POINT BEACH NUCLEAR PLANT, UNIT NO. 1

POINT BEACH NUCLEAR PLANT, UNIT NO. 2

ATTACHMENT TO LICENSE AMENDMENTS

SAFETY EVALUATION BY THE OFFICE OF NUCLEAR REACTOR REGULATION
RELATED TO AMENDMENT NO. 43 TO FACILITY OPERATING LICENSE NO. DPR-24
AND AMENDMENT NO. 48 TO FACILITY OPERATING LICENSE NO. DPR-27

FIGURE 15.6.2-1

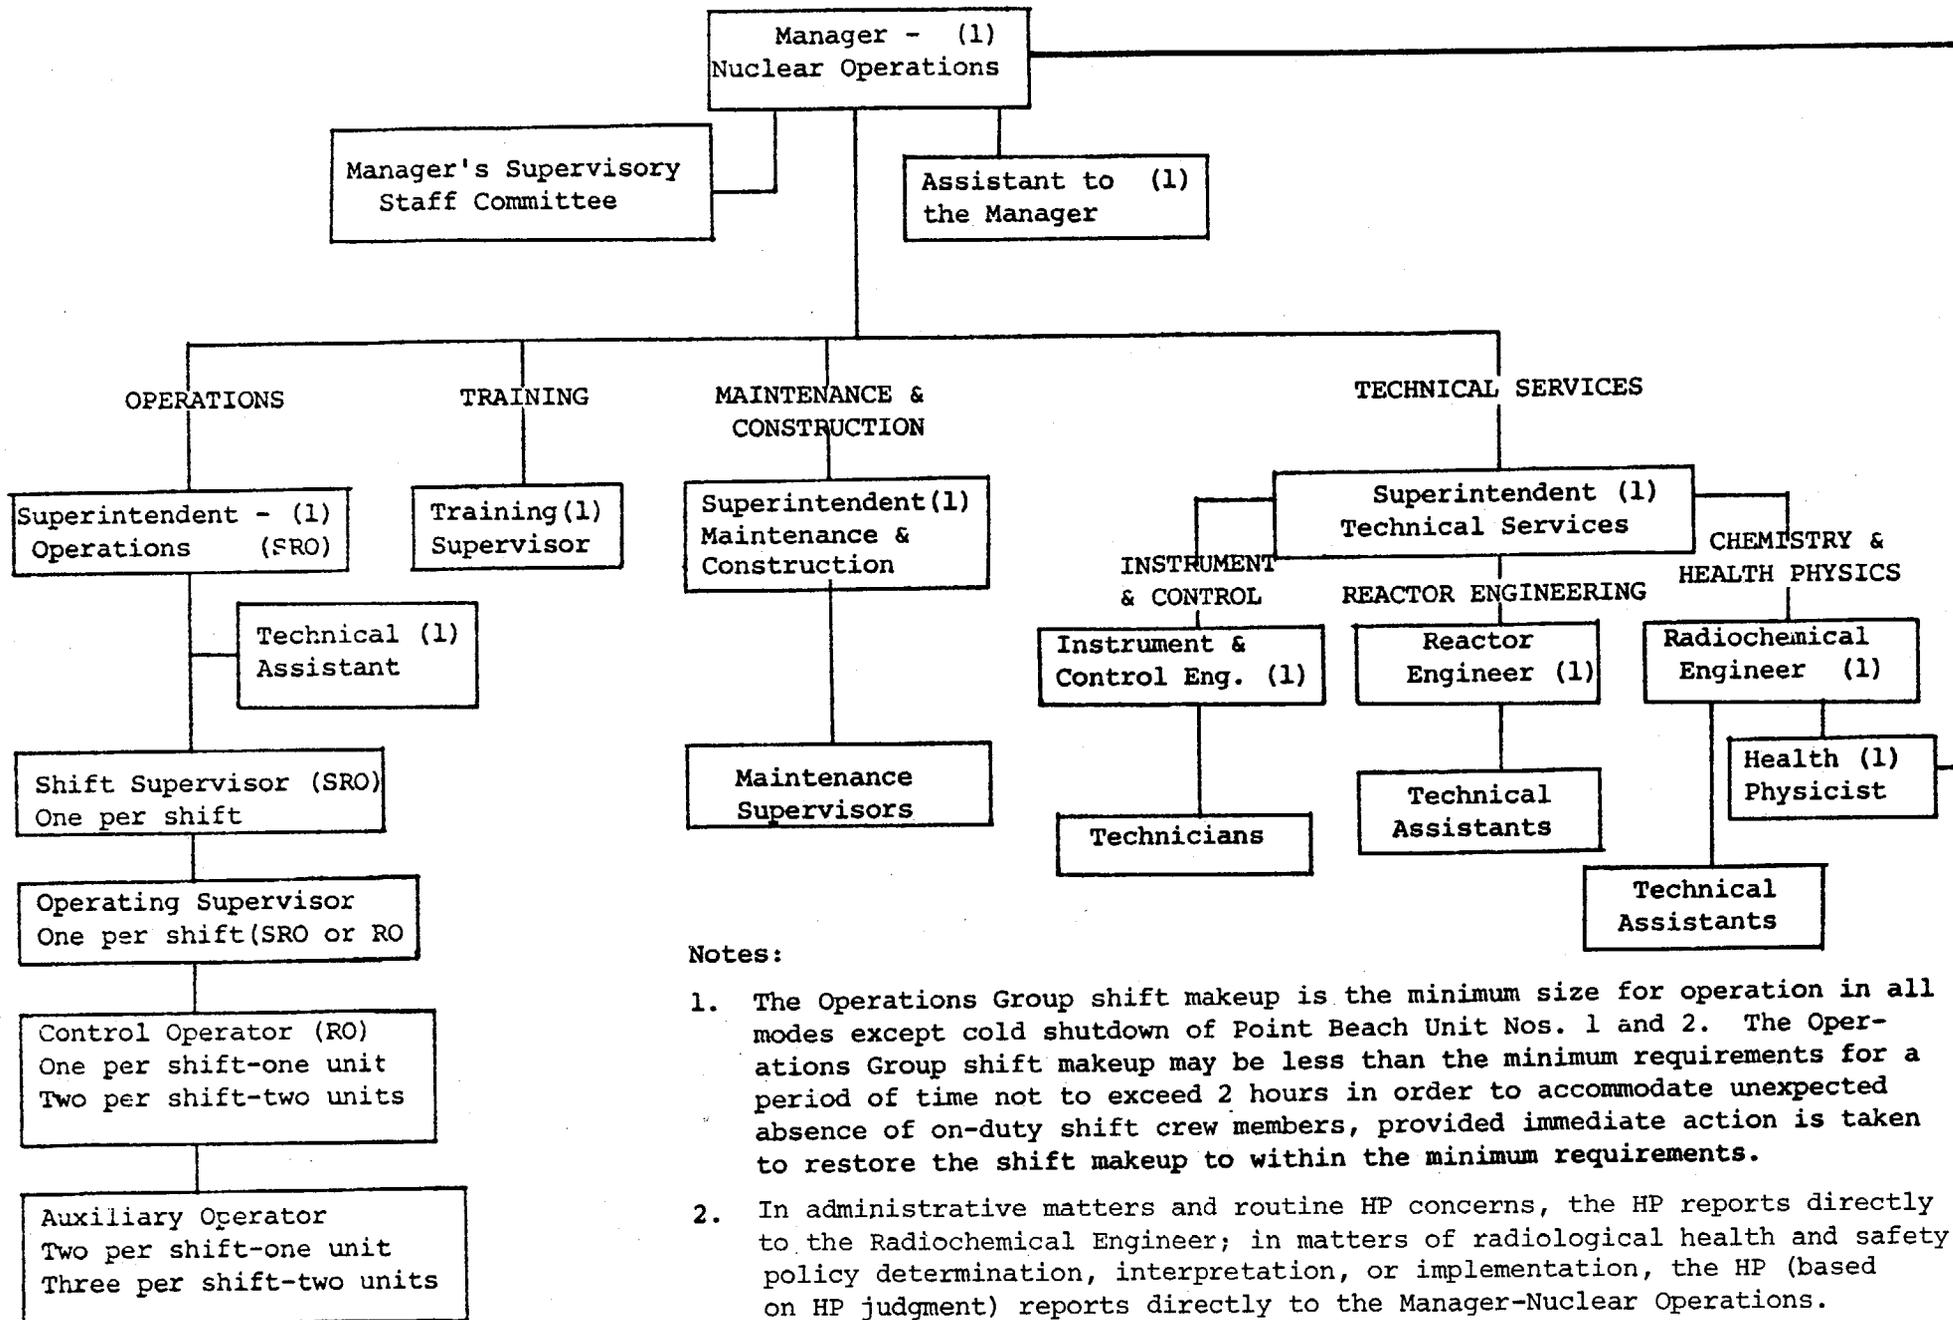
The bulk of the proposed changes involve minor clarifications, corrections and revisions to personnel and office titles and are acceptable. In addition, a new Nuclear Power Department would be created at the corporate headquarters, which consolidates the functions of Quality Assurance, Nuclear Projects, and Nuclear Operations. The creation of this department is a relatively minor change from that previously approved and is acceptable.

15.6.2.1 The offsite organization for facility management and technical support shall be as shown on Figure 15.6.2-1.

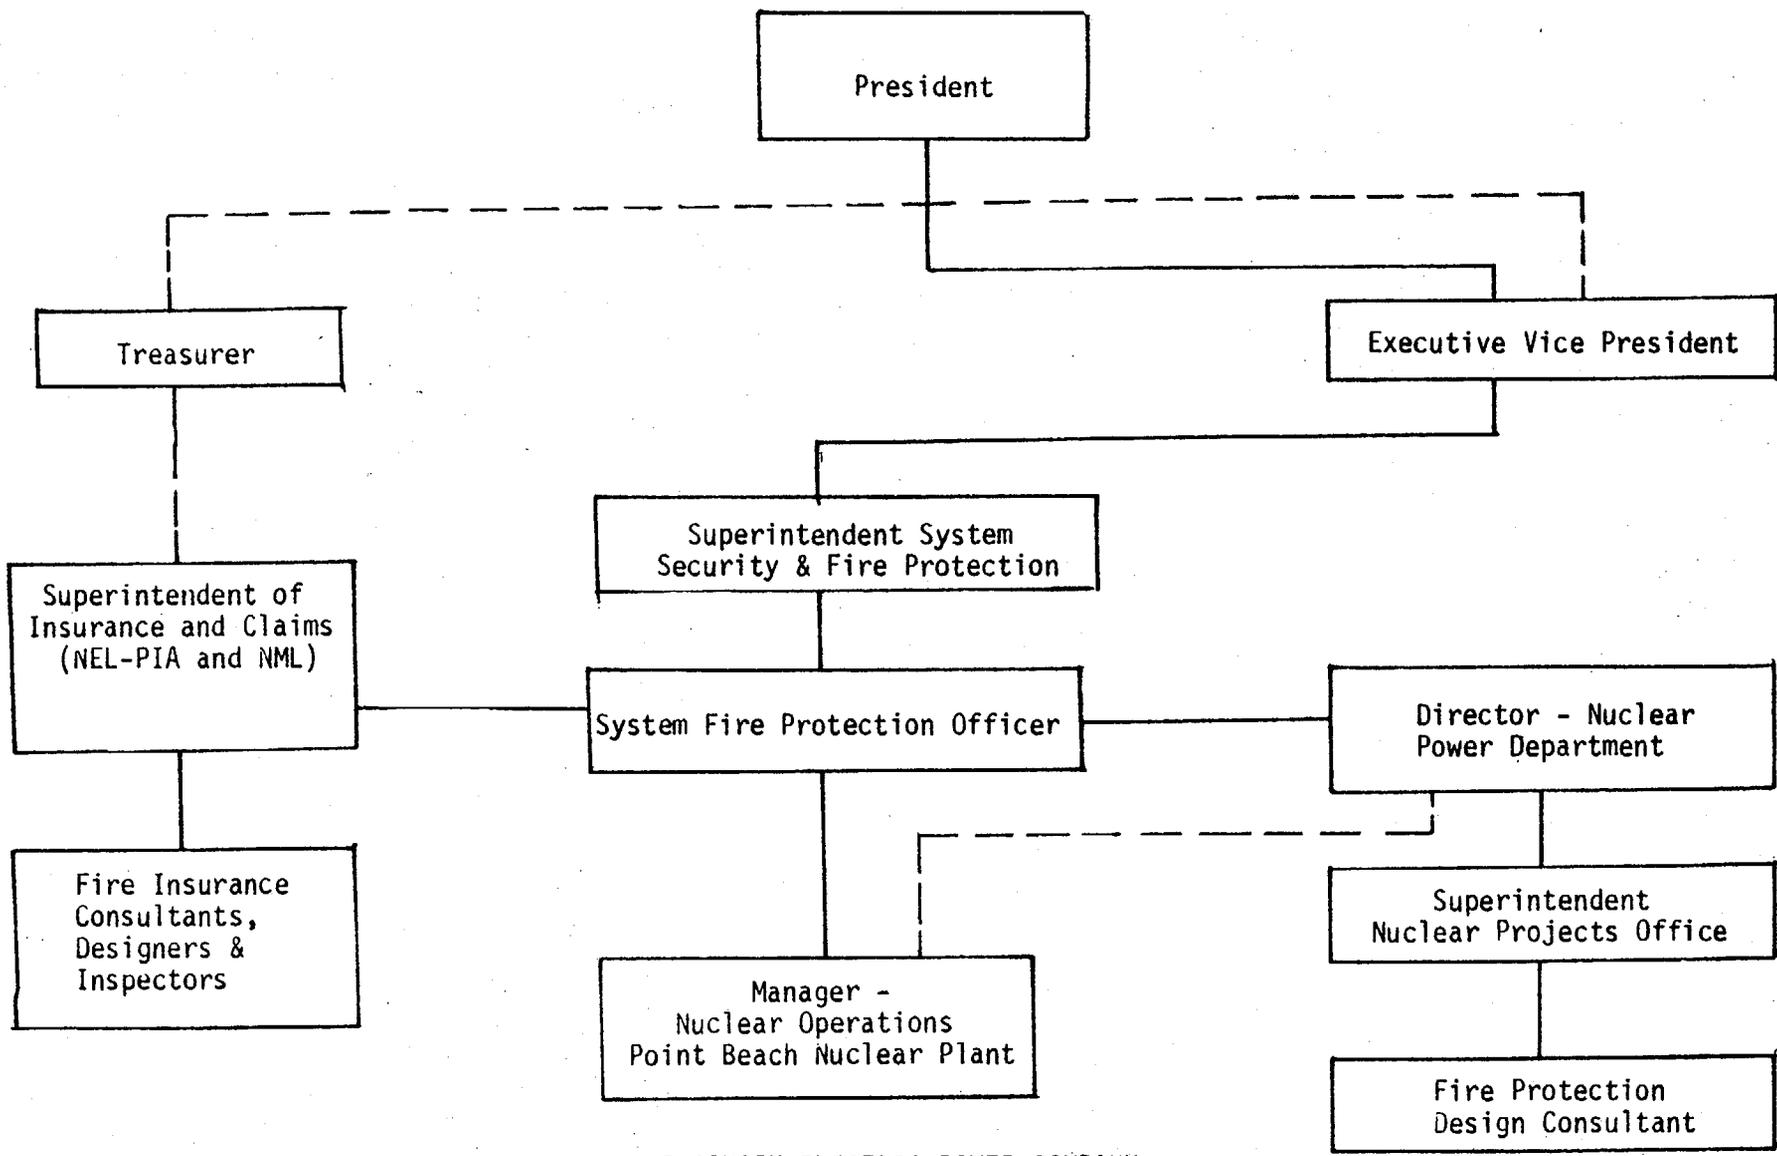
At the site level, the licensee would create a new Technical Services Department, consolidating the functions of Instrument and Control, Reactor Engineering, and Chemistry and Health Physics.

This proposed change would have the Health Physicist reporting to the Manager, Nuclear Operations, through both the Radiochemical Engineer and Superintendent Technical Services with optional reporting directly to the Nuclear Operations Manager. This organizational arrangement was unacceptable to the staff since our position with respect to the reporting requirements of the in-plant Health Physicist is as stated in Regulatory Guide 8.8; namely, that "The Radiation Protection Manager should have direct recourse to responsible management personnel in order to resolve questions related to the radiation protection program."

The issue was resolved by showing a solid reporting line from the Health Physicist (HP) directly to the Manager-Nuclear Operations and delineating criteria for direct reporting when necessary in the HP's judgment. This organizational arrangement allows (in fact requires) direct recourse by the HP to the highest on-site authority when necessary to resolve questions related to important radiation protection matters. The licensee has agreed to these changes which we find acceptable.
